**TOWN OF LOS GATOS**
**PLANNING COMMISSION**
**REPORT**

MEETING DATE: 06/11/2025

ITEM NO: 2

SUBJECT: Consider a Request for Approval to Construct a New Single-Family Residence with a Reduced Rear Yard Setback, Site Improvements Requiring a Grading Permit, and Removal of Large Protected Trees on a Nonconforming Vacant Property Zoned R-1:20. **Located at 45 Reservoir Road.** APN 529-33-054. Architecture and Site Application S-22-048. Categorically Exempt Pursuant to CEQA Guidelines Section 15303: New Construction. Property Owner: Farnaz Agahian. Applicant: Gary Kohlsaat, Architect. Project Planner: Sean Mullin.

# Appendix A: Tree Inventory Map and Proposed Site Plan

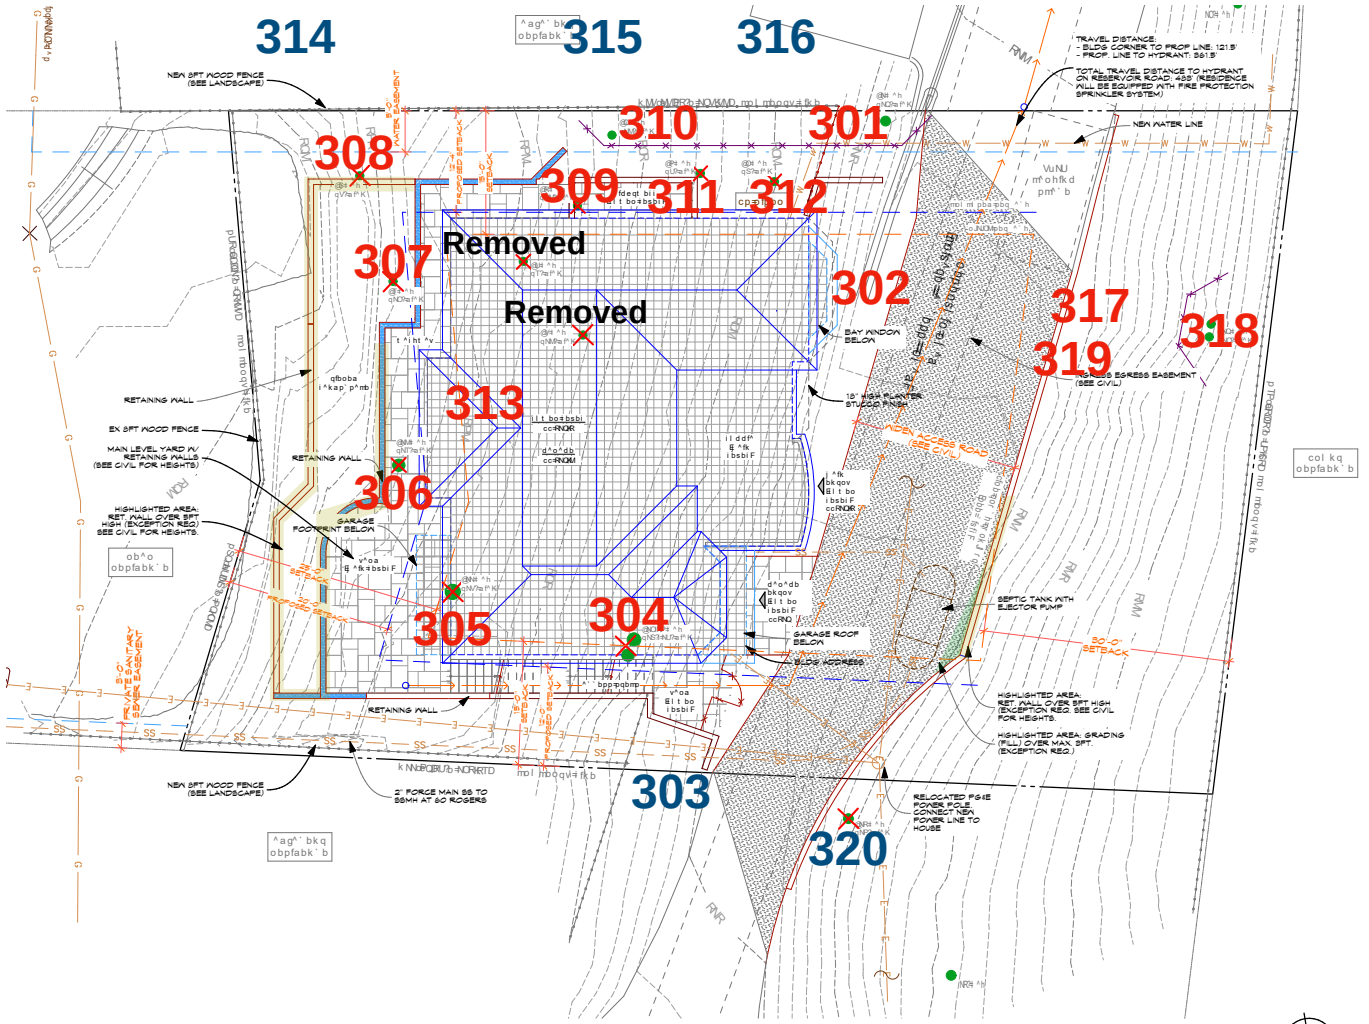
Trees #302, #303, #313, #317, #319, #314, #315, and #316 are not indicated on the plans. There are discrepancies between the civil, landscape, and architectural plans. The architectural plans (A4 ), landscape plan (A5), civil drawings (C-7) indicate the lower coast live oak #318 is to be retained but the Grading and Drainage Plan C-4 clearly indicates this tree would be highly impacted by the keyway and grading in this area. I believe this tree (#318) is critical for screening. Architectural sheets A4 and A5 also indicate coast live oak #320 is to be removed, however the tree is indicated to be on the adjacent property.

Looking at the civil plans all the trees on site would be required to be removed. The architectural plans indicate #301, #310, and #318 are to be preserved but again are in conflict with the grading and drainage plans. There are five trees that could be moderately impacted located on the adjacent properties which are #314, #315, #316, #303, and #320. Trees #314, #315, #316 will need to be located to obtain exact distances from the excavation to the trees. #303, and #320 are near the road improvements and will need to be preserved. Fifteen trees are to be highly impacted and five moderate to highly (Chart 4).

There are discrepancies between the civil, landscape, and architectural plans. The architectural plans (A4 ), landscape plan (A5), civil drawings (C-7) indicate the lower coast live oak #318 is to be retained but the Grading and Drainage Plan C-4 clearly indicates this tree would be highly impacted by the keyway and grading in this area. I believe this tree (#318) is critical for screening. Architectural sheets A4 and A5 also indicate coast live oak #320 is to be removed, however the tree is on the adjacent property. Looking at the civil plans all the trees on site would be required to be removed. The architectural plans indicate #301, #310, and #318 are to be preserved but are in conflict with the grading and drainage plans. There are five trees that could be moderately impacted on the adjacent properties which are #314, #315, #316, #303, and #320. Trees #314, #315, #316 will need to be located to obtain exact distances from the excavation to them. #303, and #320 are near the road improvements and will need to be preserved. Fifteen trees are to be highly impacted and five moderate to highly depending on their actual location.

A-3

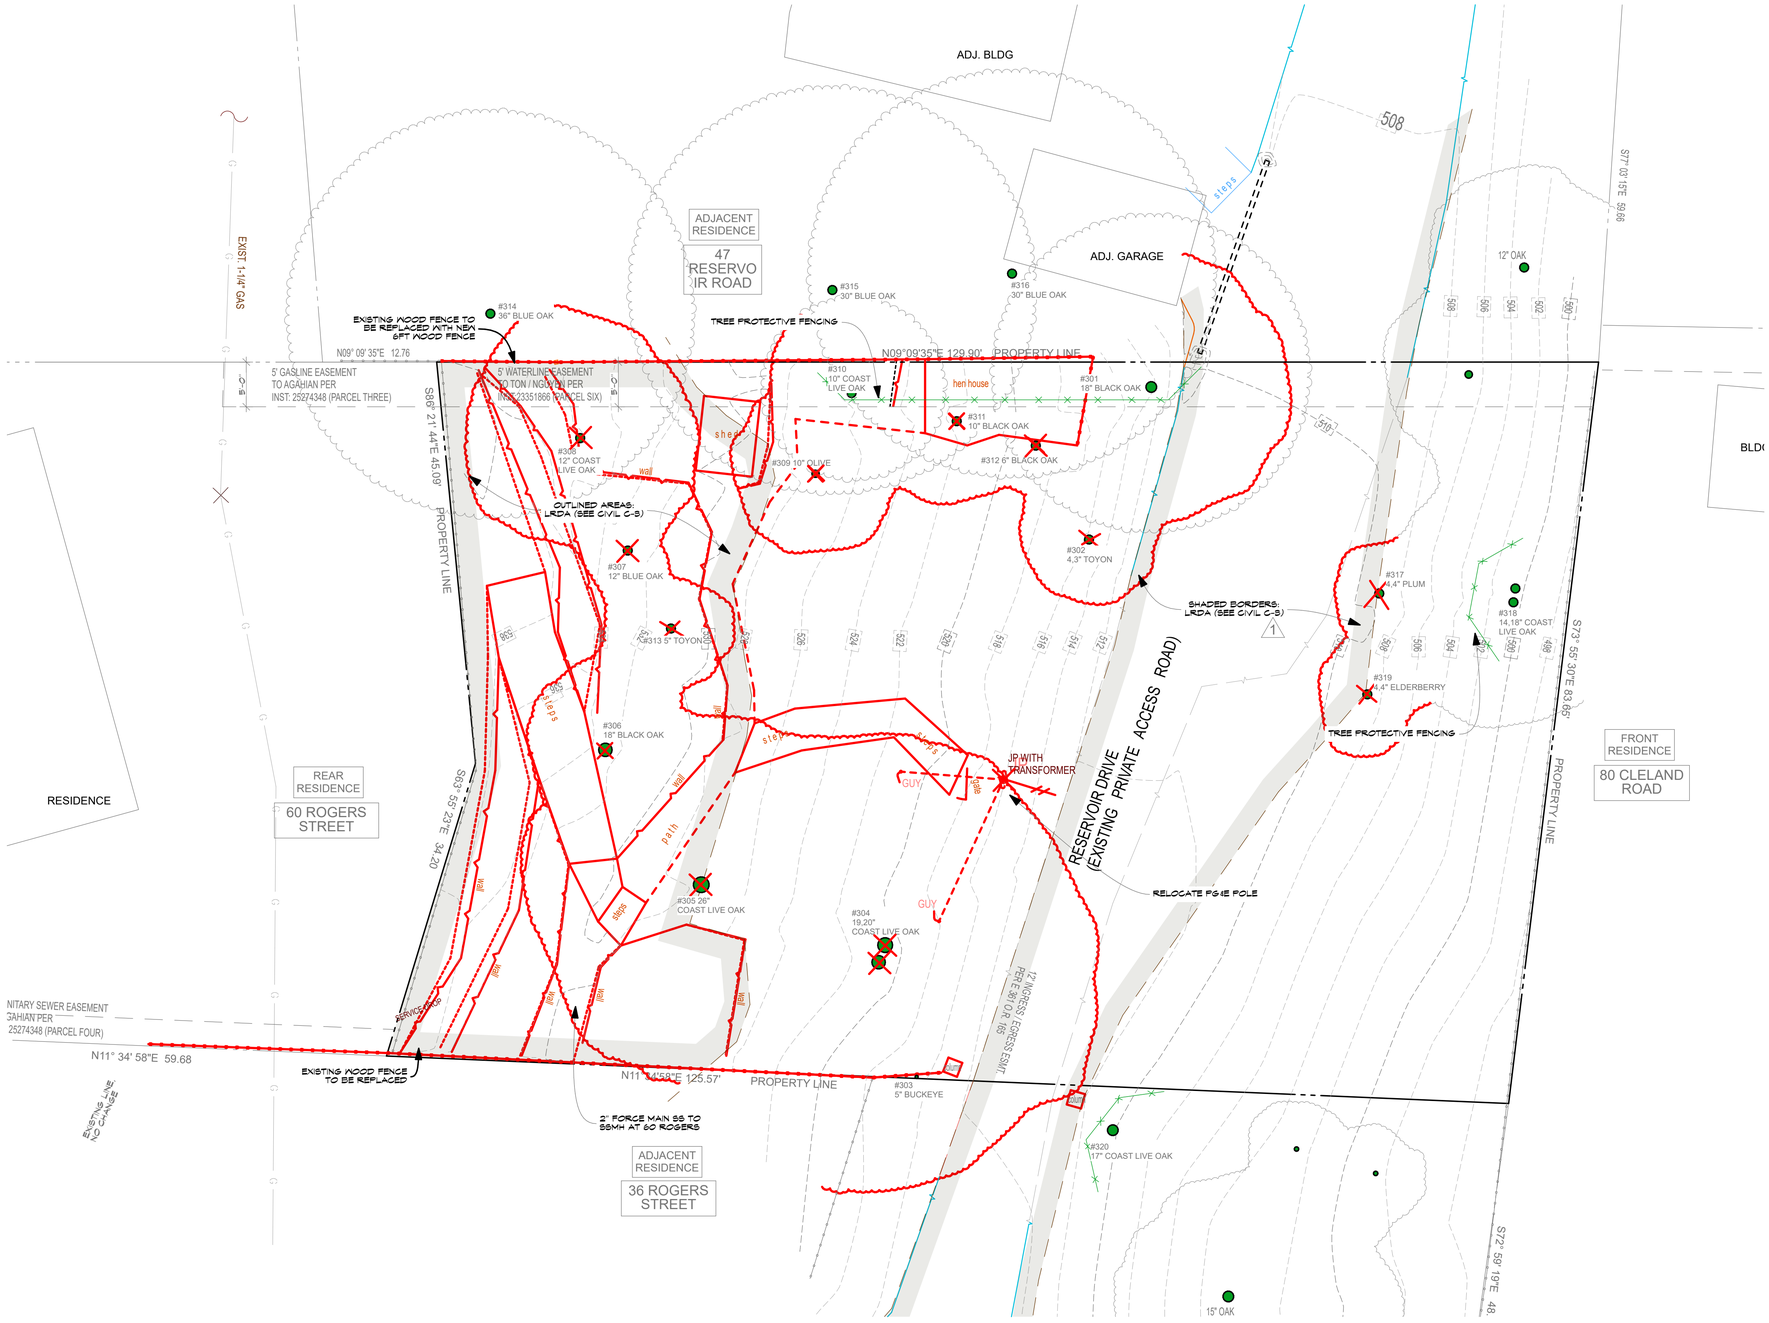
The LRDA on the subject property is concentrated in the southern (rear) portion of the property and the area of the existing private road (Exhibit 10, Sheet A-3). The LRDA at the rear of the lot is further constrained with the majority of it being located with the required rear setback of 25 feet and side setbacks of 15 feet. This leaves a very limited area of LRDA outside of the required setbacks.

SHEET A-4

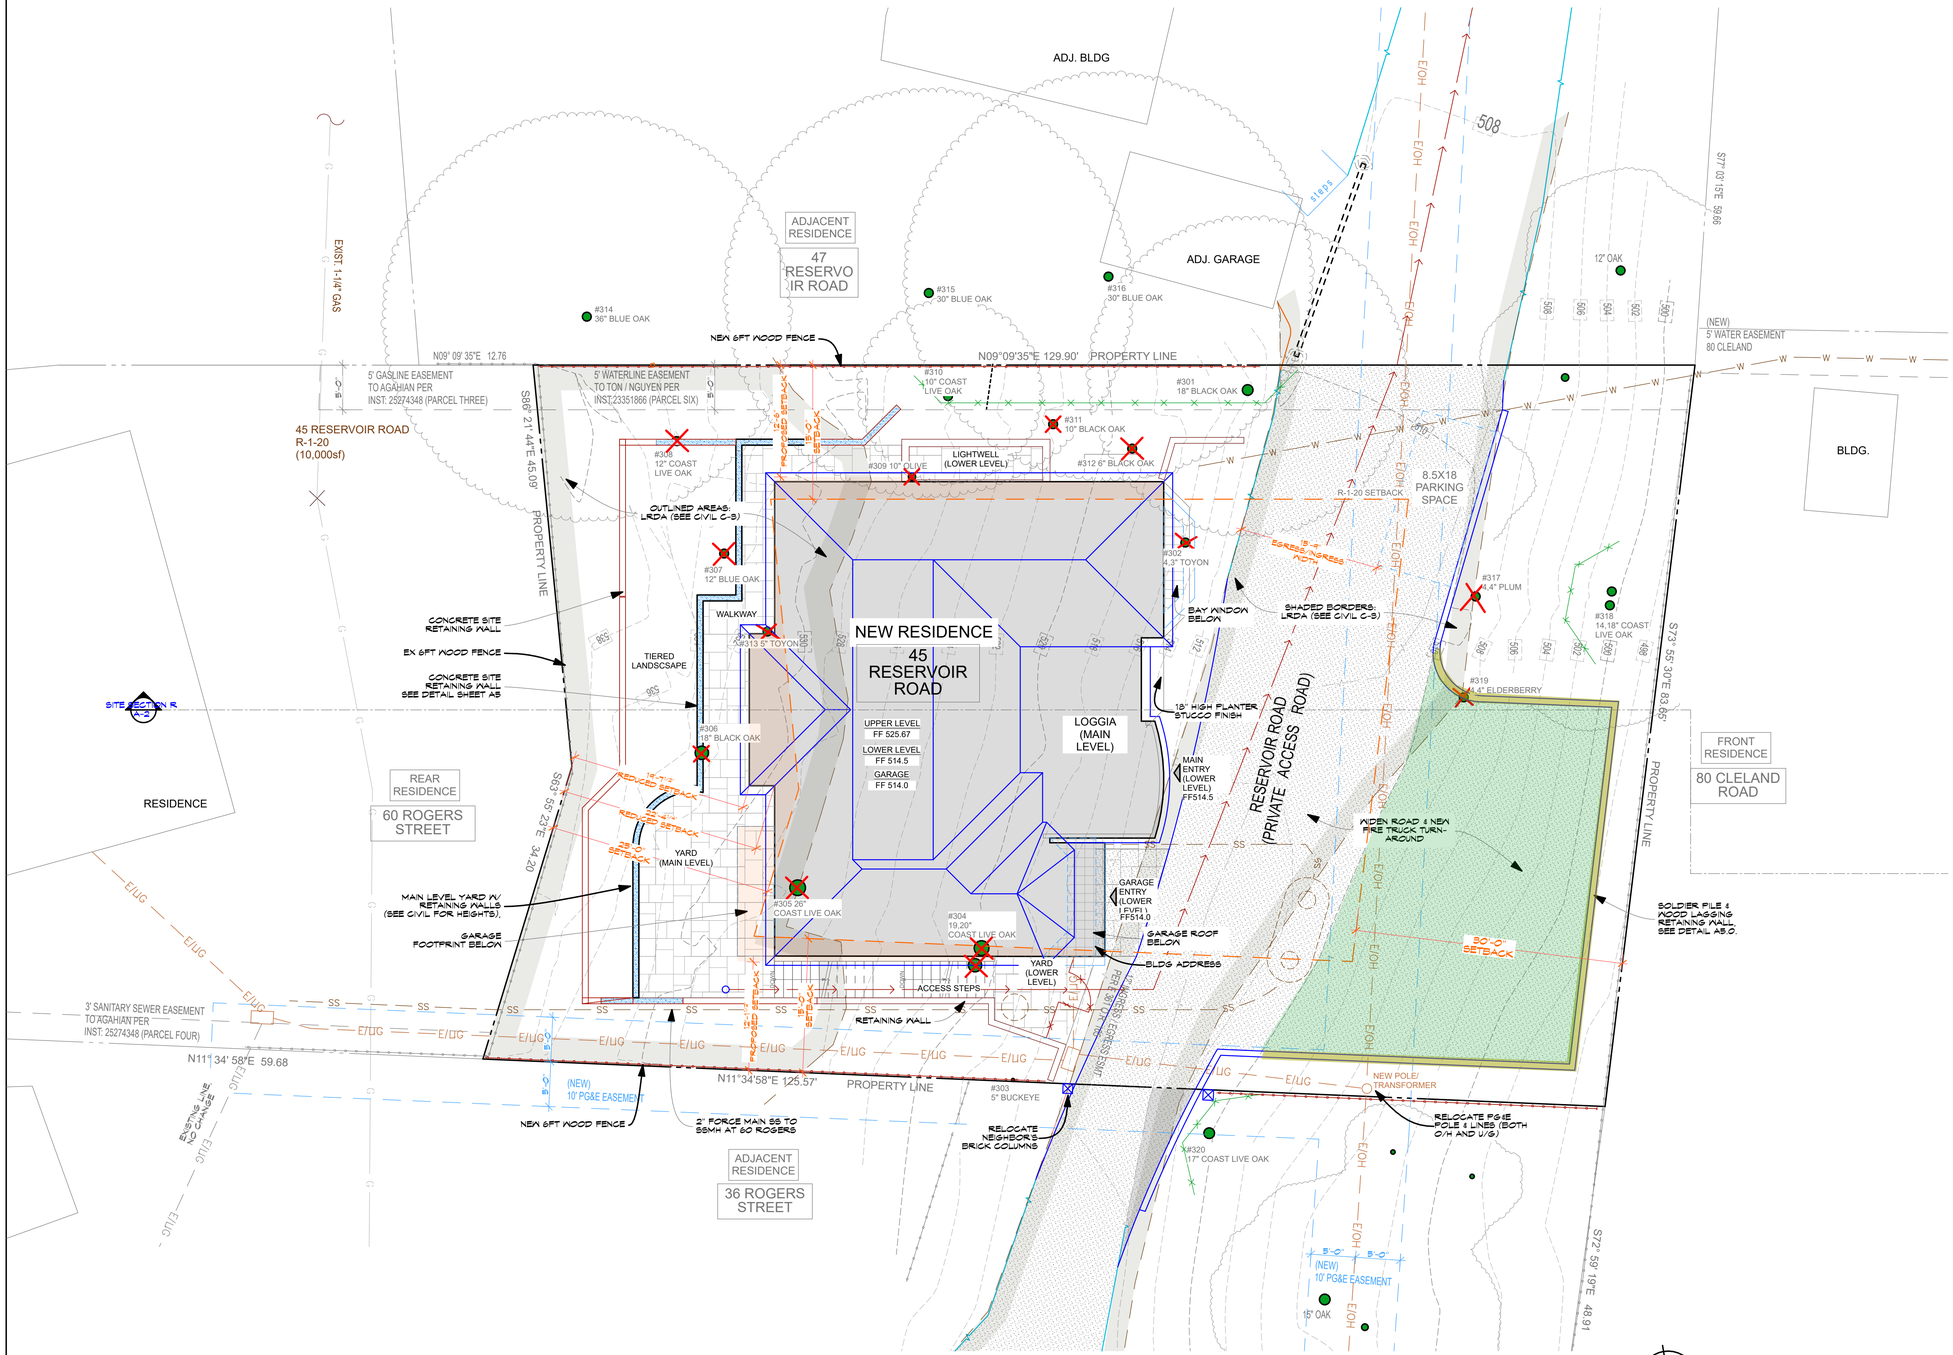
108. **TURNAROUND: (As noted on sheet A-4 and sheet 4) (a) Turnarounds are required on driveways and dead- end roads. (b) The minimum turning radius for a turnaround shall be forty (40) feet, not including parking, in accordance with the figures in 14 CCR §§ 1273.05(e) and 1273.05(f). If a hammerhead/T is used instead, the top of the “T” shall be a minimum of sixty (60) feet in length.(c) Driveways exceeding 150 feet in length, but less than 800 feet in length, shall provide a turnout near the midpoint of the driveway. Where the driveway exceeds 800 feet, turnouts shall be provided no more than 400 feet apart. (d) A turnaround shall be provided on driveways over 300 feet in length and shall be within fifty (50) feet of the building.(d) Each dead-end road shall have a turnaround constructed at its terminus. Where parcels are zoned five (5) acres or larger, turnarounds shall be provided at a maximum of 1,320 foot intervals.(e) Figure A. Turnarounds on roads with two ten-foot traffic lanes. California Code of Regulations, Title 14, Division 1.5, Chapter 7, Subchapter 2, Articles 1-5, § 1273.05.

112. FIRE DEPARTMENT (ENGINE) DRIVEWAY TURNAROUND REQUIRED: (As noted on sheet A-4 and sheet 4) Provide an approved fire department engine driveway turnaround with a minimum radius of 36 feet outside and 23 feet inside. Maximum grade in any direction shall be a maximum of 5%. Installations shall conform with Fire Department Standard Details and Specifications D-1. CFC Sec. 503.
    -Approved Request of Exception PC 24-2558. See comment number 108 for conditions of approval.

Modified Fire Truck Turnaround Diagram
scale: 1"=10'

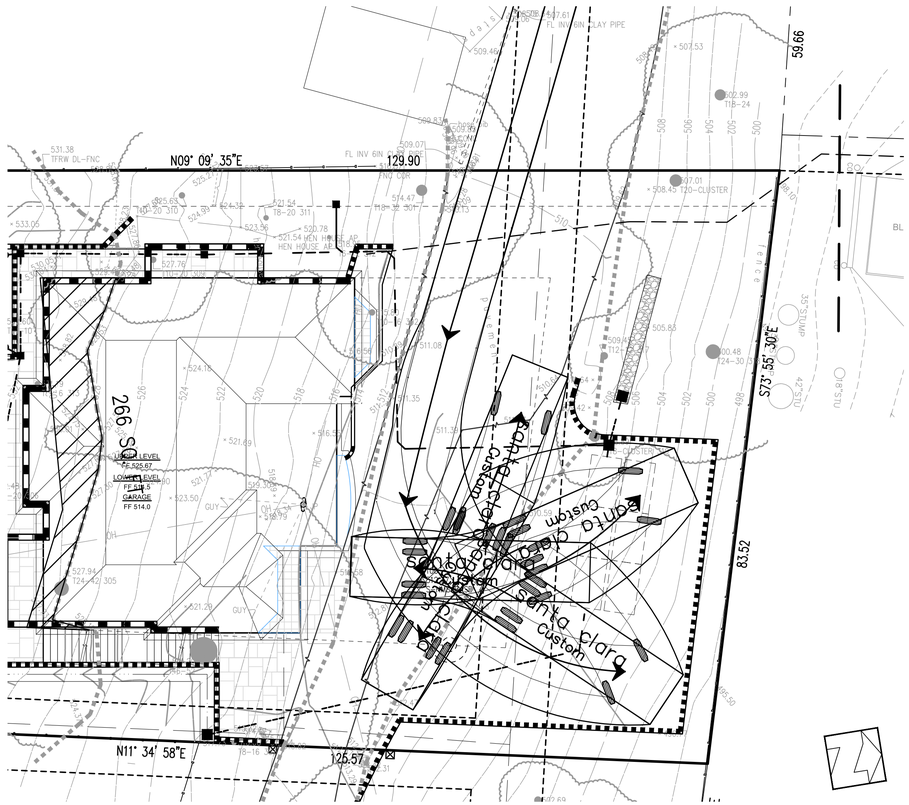
A majority of this road will also be multi-tasked as the fire truck turn-around and the back-up space for the garage. Our civil engineer has explored many configurations with the Fire Department, and we were approved with a modified turn-around area (shown on civil sheet 4). This large flat area needs to be created with grading/fill and retaining walls. It is also the reason we don't have room for 4 guest parking spaces on our lot and why our driveway is shorter than the required 18ft length. Moving the road any more than proposed will not only take away the turn-around area, it will create more problems for our neighbors since we will need to extend the grading work well into their properties.
